Re: Revised Colusa Subbasin Groundwater Sustainability Plan

AquAlliance, the California Sportfishing Protection Alliance, and the California Water Impact Network (hereinafter AquAlliance) submit the following comments and questions on the Revised Colusa Subbasin Groundwater Sustainability Plan (“Revised GSP” or “Plan”) to the Colusa Groundwater Authority and the Glenn Groundwater Authority GSAs (“GSAs”).

-  Military Bases - REMOVE
-  WellSTAR - All Wells - REMOVE

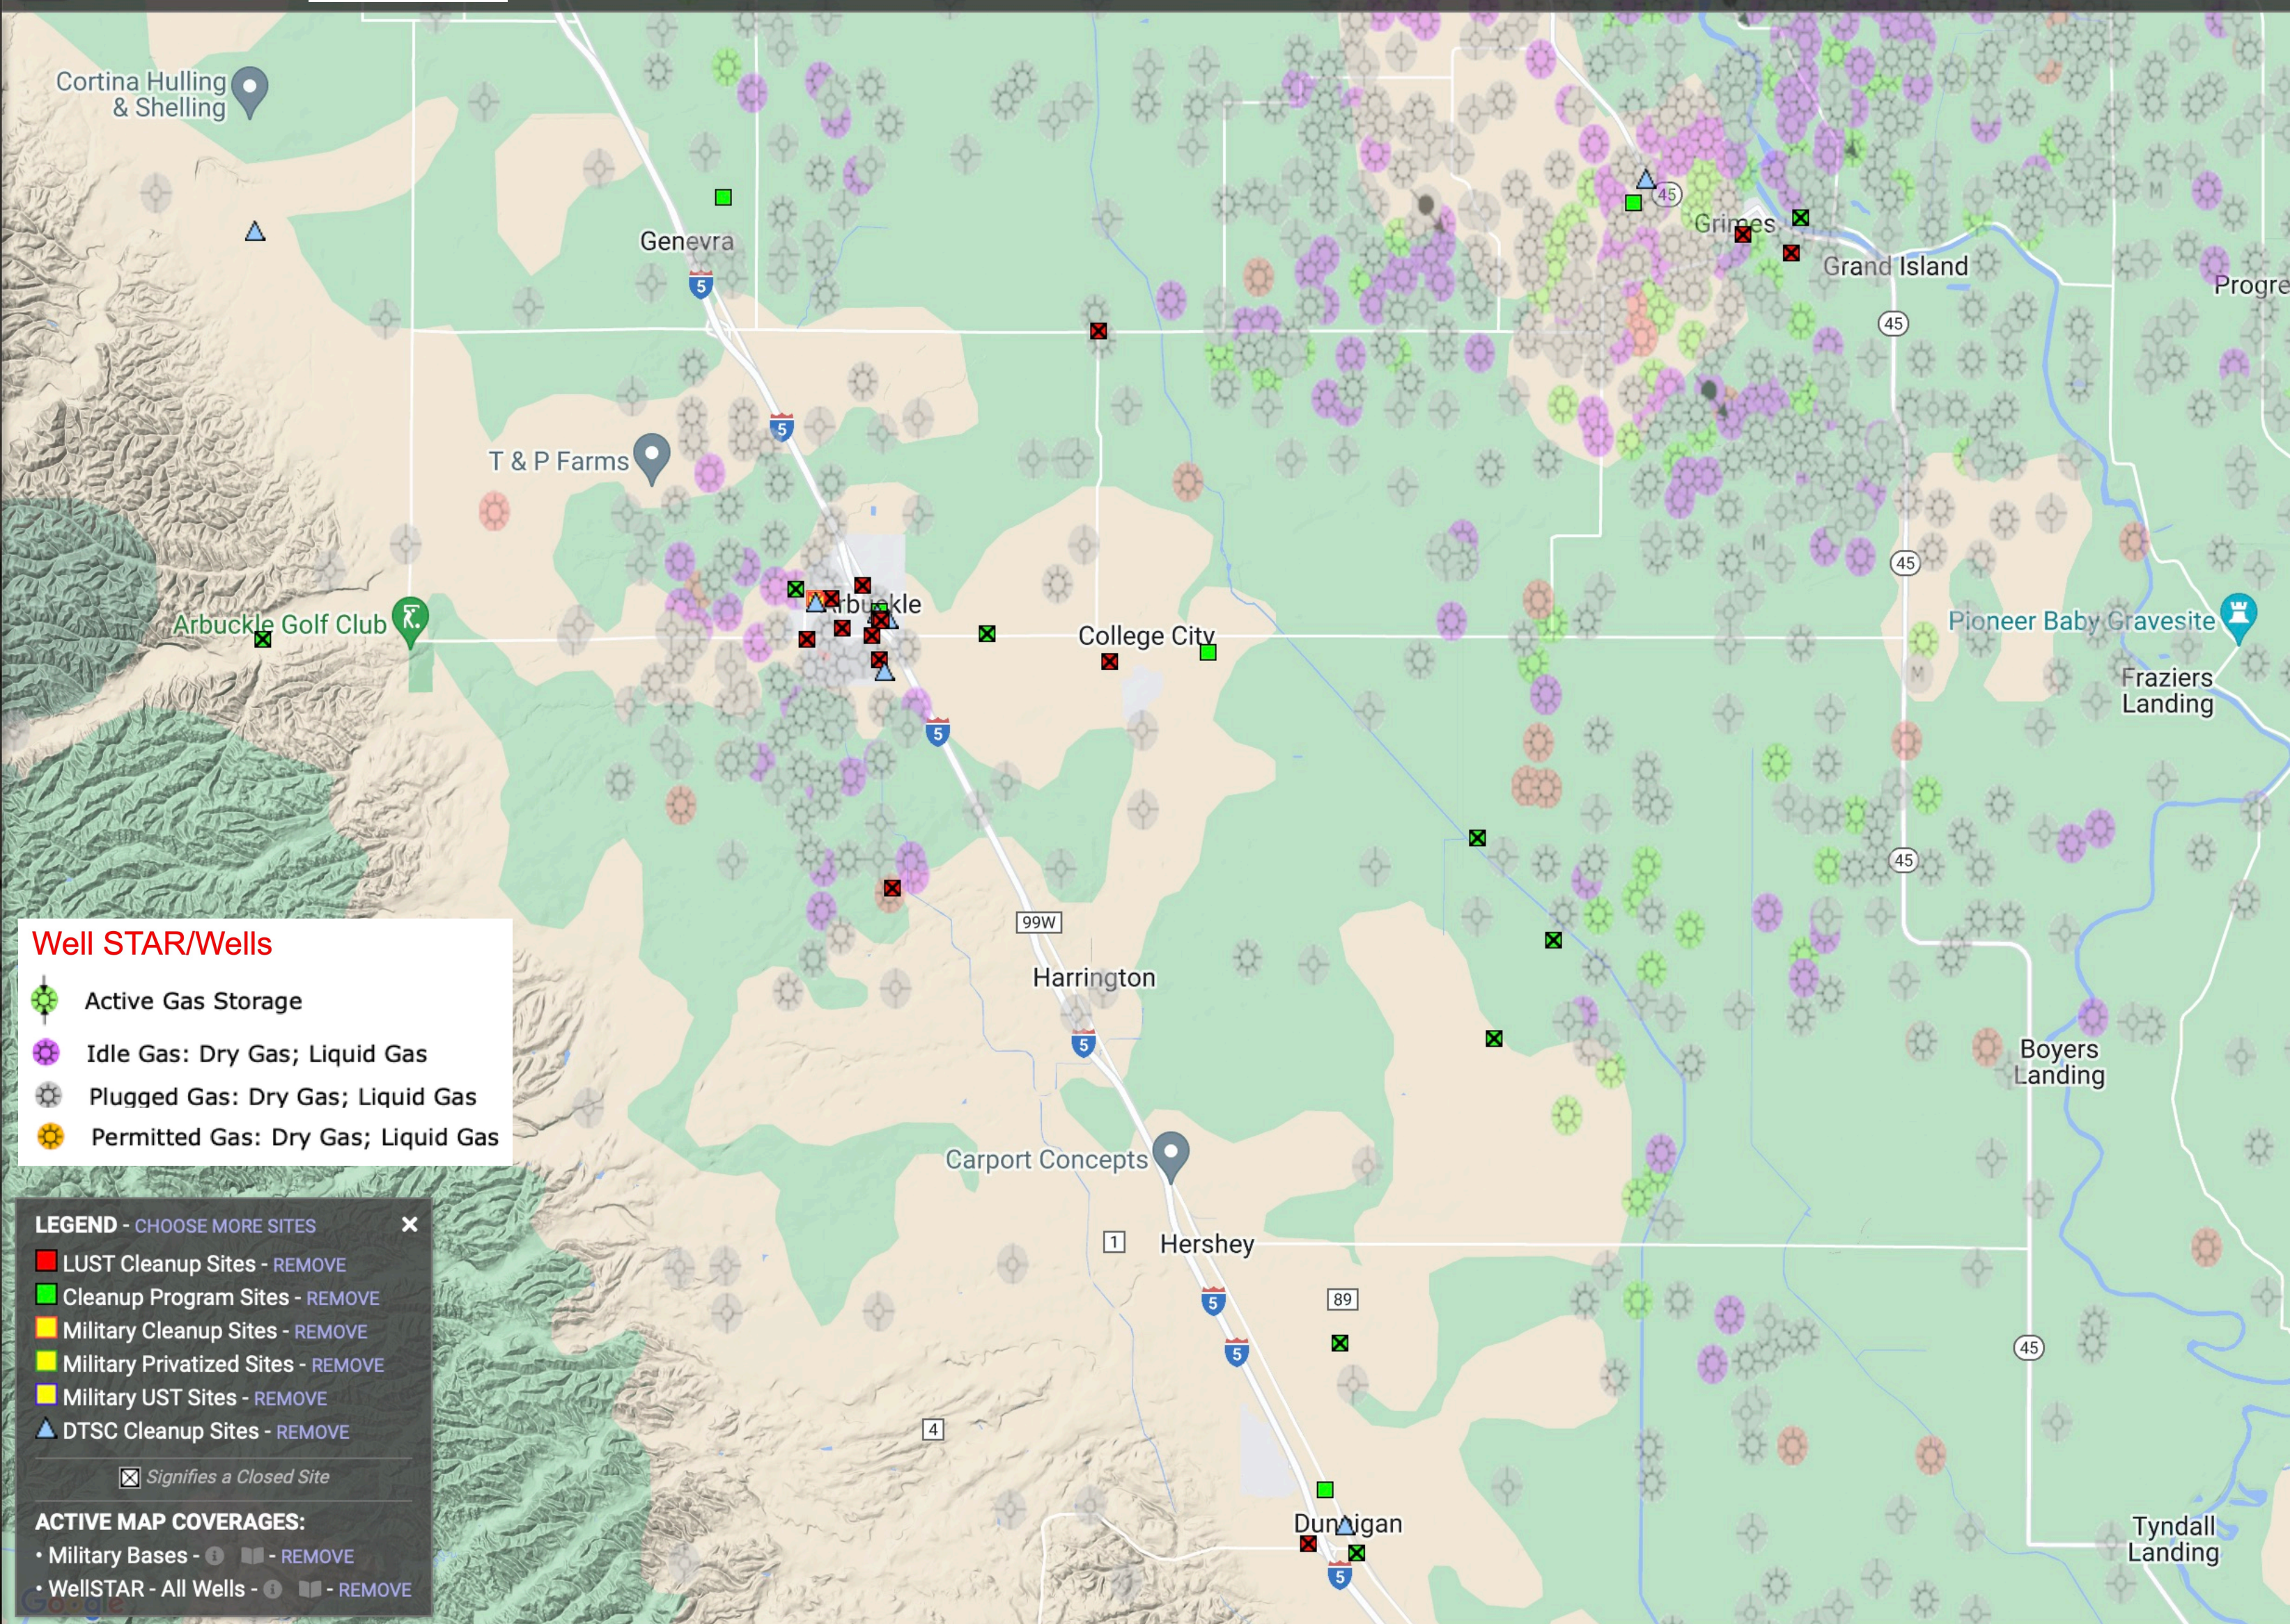
The attached six screen captures of the Geotracker website show that there are a number of known contaminated sites and oil and gas wells throughout the Subbasin. The Revised GSP doesn't provide an analysis of whether the monitoring network shown in Figure 4-3 is adequate to collect sufficient data to demonstrate short-term, seasonal, and long-term trends in groundwater for known contaminants for each applicable principal aquifer to determine groundwater quality trends for water quality indicators to address known water quality issues (CCR § 354.34(a), (c)(4)).

Figure 4-3

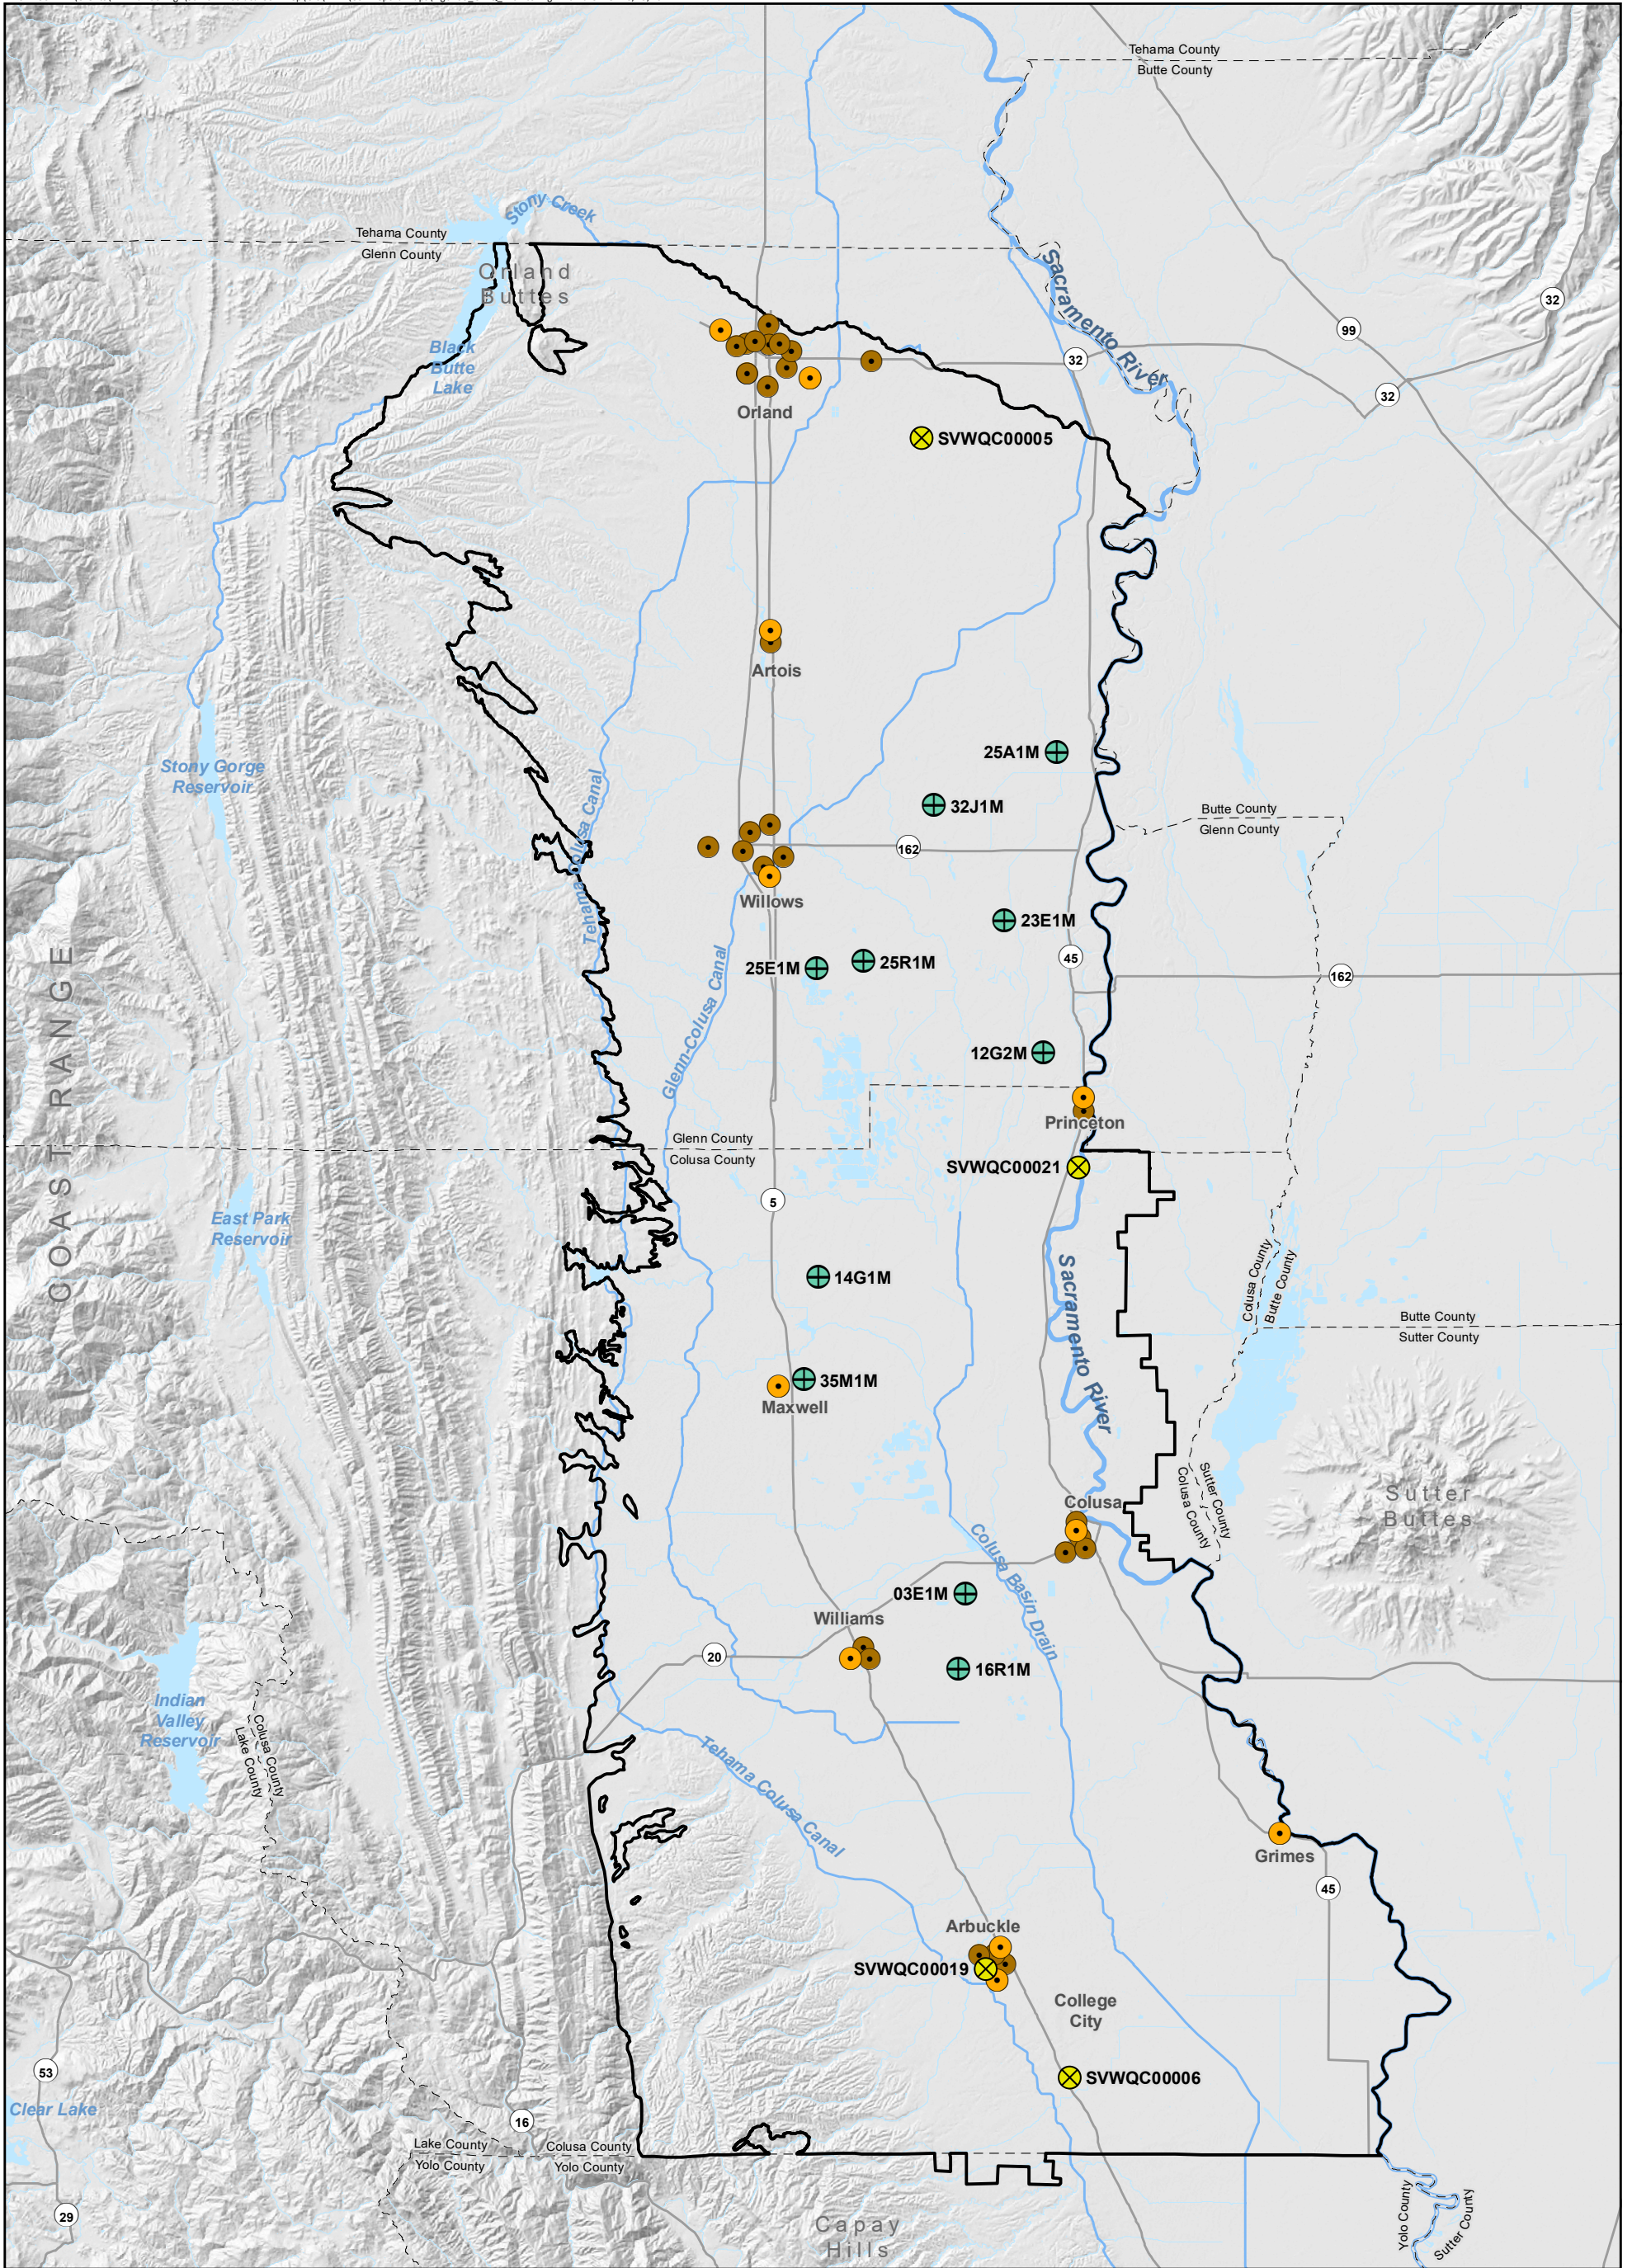
The Revised GSP doesn't provide information as required by CCR § 354.28 with “[k]nown groundwater quality issues that may affect the supply and beneficial uses of groundwater, including a description and map of the location of known groundwater contamination sites and plumes.” The information on known groundwater contamination sites is readily available from the SWRCB's Geotracker² website. In addition to known contaminated sites, the Geotracker site allows for the display of the known oil and gas well using WellSTAR. A set of screen capture maps taken from Geotracker on April 16, 2024, are attached along with Revised GSP Figure 4-3, which shows the groundwater quality monitoring network.

Figure 5-4. Groundwater Level Representative Monitoring Network and Identification of Focus and Non-Focus RMS Wells.

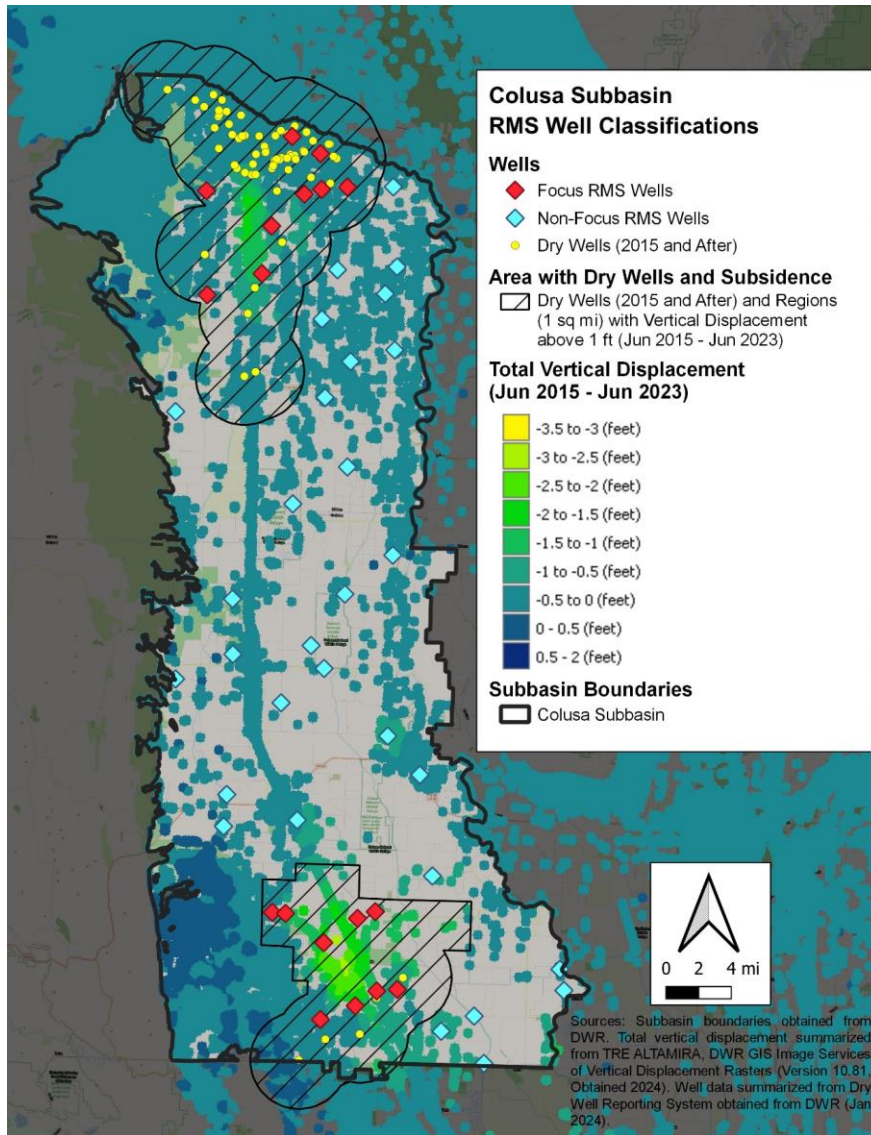
a) The Revised GSP indicates that the Focus RMS wells were selected in part because of the ongoing subsidence in the area (see attached Figure 5-4). Maps of the Colusa Subbasin area show categories of measured benchmark subsidence from 2008 to 2017 in the Revised GSP Figure 3-31 (p. 3-79, pdf p. 189), and the October 2018-2019 to October 2022-2023 InSAR measurements also show subsidence in Figure 3-32 (page 3-80, pdf 190).

a) Attached are two maps from the Revised GSP that show the general outline of the Focus RMS wells area overlain on the historical June 2015 to June 2023 cumulative vertical subsidence, Figure 5-4 (page 5-37, pdf 309), and both the Focus and Non-Focus RMS wells with the well identifications, Figure 4-6 (page 4-36, pdf 268). Apparently the GSAs have determined that “undesirable results” have occurred in the Subbasin, because the Revised GSP now breaks the Representative Monitoring Site (RMS) wells into two groups based on the occurrence of undesirable results.
